RotorSport UK Ltd Service Bulletin

Title: Rotax CHT_CT gauge placard		
SB No.: 094 Iss1	Related documents MC No: MC-314 CCAR No.: none	Compliance Category: OPTIONAL or RECOMMENDED or MANDATORY
Applicability		
Aircraft type & model: All those fitted with Rotax new-design cylinder head but having CHT gauge display	Aircraft serial Nos. affected: See list below	
This form is the response from RotorSport UK Ltd either against a problem found in the product in service requiring a containment or rectification action, or as service information for aircraft modification incorporation. For help, contact RotorSport on 44(0)1588 650769, or email info@rotorsport.org.		
<u>Reason and overview of the Service Bulletin (cause of problem if known)</u>		
<p>The latest Rotax engine cylinder head design places the temperature sensor in the water jacket, so the instrument display is considered to be coolant temperature (CT) with maximum allowed value 120degC and not Cylinder Head Temperature (CHT) which had maximum value 135degC.</p> <p>Until bespoke CT gauges are available a placard kit has been made available by RSUK to convert existing CHT gauges to CT display and the placards may be fitted to affec

Identification of engine type:

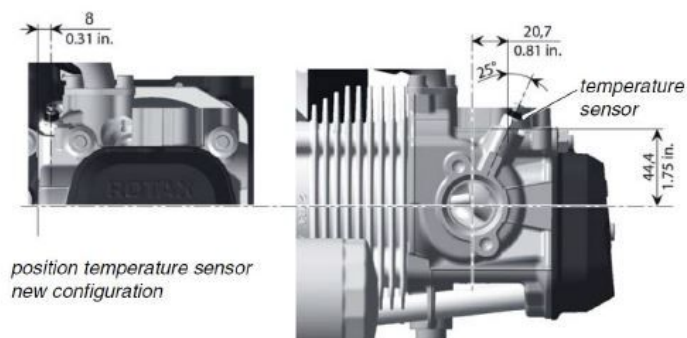
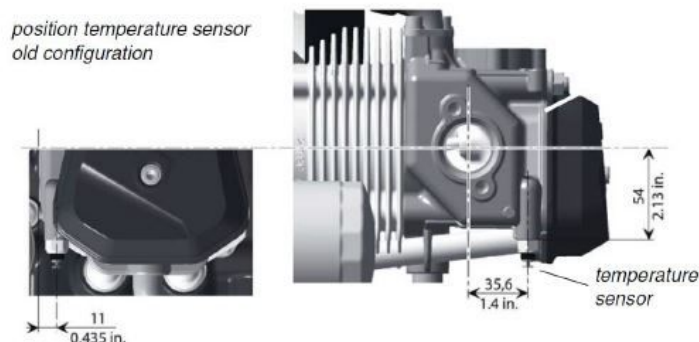
1. Verify that the engine fitted requires the gauge modification (see photos below)
2. Clean the glass of the CHT gauge using Ambersil LO30 solvent on a soft cloth
3. Using a scalpel blade lift the red line from the placard sheet. Affix the red line directly over the 120degC marker
4. Affix the 120degC icon over the pointer's pivot to the right of the gauge
5. Using finger pressure press down on the adhesive pieces to ensure no air-bubbles beneath.
